This page lists the known errors on the gm5x5x5 PCBs. There are no known issues with the bulk order run (white pcbs), the following information is valid **only** for the prototype run (green pcbs).

#1 Silkscreen error

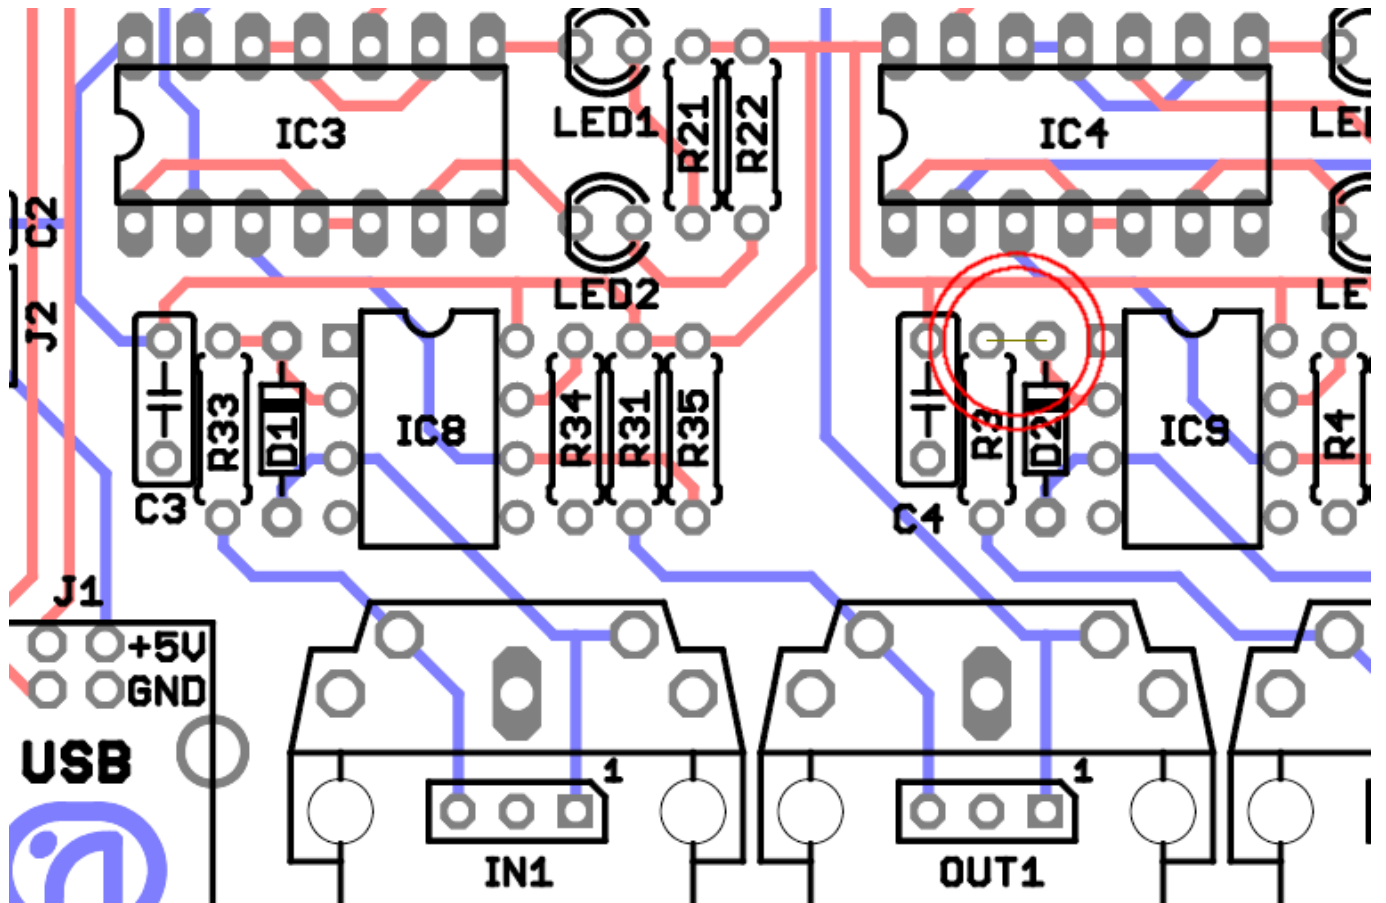
Problem: The silkscreen has the EEPROM the wrong way around - Pin 1 should be facing IC5.

Solution: Stick the EEPROM in the other way around, with the "notch" facing IC5.
